Office Action Summary	Application No. 10/574,092	Applicant(s) NIGRO, NELLO	
	Examiner GERALD L. SUNG	Art Unit 4156

DETAILED ACTION

Fig. 1
(Prior Art)

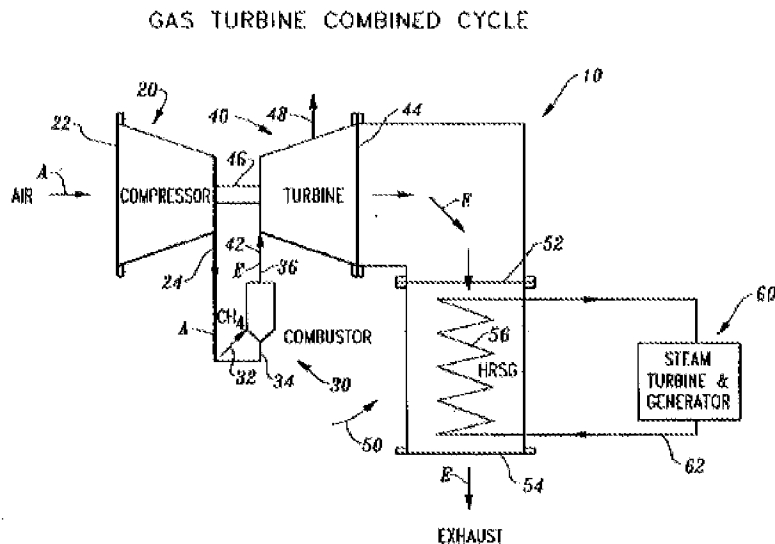
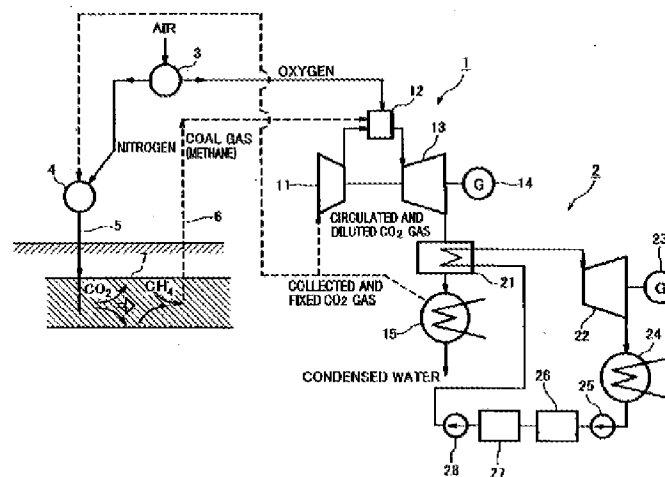
9. Regarding claim 1, referring to figure 1 below, Viteri et al. disclose a combined cycle power plant where in the operation of the disclosed power plant would have yielded the method of supplying methane and air to a combustor to drive a gas turbine, supplying the hot flue gas to a heat recovery steam generator to create and providing steam to drive a steam turbine. Referring to figure 2 below, Ooka et al. teach the use of a coal bed as a source for methane to drive the gas turbine, the use of flue gas in combination with an oxidizer and a fuel prior to combustion, and the use of a coal bed as a storage region for flue gas. It would have been obvious to one of ordinary skill in the art at the time of the invention to include the use of the coal bed taught in Ooka

10. Further regarding claim 1, one of ordinary skill in the art at the time of the invention would have found it obvious to combine the conventional combined cycle power plant as disclosed by Viteri et al. (figure 1) where the oxidizer used in the combustion process is air and the reduced emissions combined cycle power plant disclosed by Ooka where the oxidizer used in the combustion process is oxygen in order to provide a secondary system as a back up measure to accommodate events such as peak loading of the power plant, transient states (start up/shut down), and schedule maintenance or failure. The combination of the combined cycle power plant as disclosed by Viteri et al. and the reduced emissions combined cycle power plant disclosed by Ooka et al. does not lend itself to be patentably distinguishable because one of ordinary skill in the art at the time of the invention would have found the combination of the two previously known power plants above to yield predictable results.

12. Regarding claims 3 and 4, referring to figure 1 above, Viteri et al., as previously modified by Ooka et al., disclose the use of flue gas predominantly composed of carbon dioxide supplied to the compressor (11), as indicated by the dashed arrow at

compressor (11), and then to the combustor (12). The remainder of the carbon dioxide is sent to the gas compression module (4) and then to the coal bed for storage.

14. Regarding claims 6 and 7, referring to figure 2 above, Viteri et al., as previously modified by Ooka et al., teach the use of the same coal bed seam for storage and for extraction of methane, as illustrated.

17. Regarding claim 10, referring to figure 2 above, Viteri et al., as previously modified by Ooka et al., disclose a compressor (11) which compresses a portion of the uncondensed carbon dioxide leaving exhaust gas condenser (15), as indicated by the dashed arrow at compressor (11), and then supplying the carbon dioxide to the combustor (12).
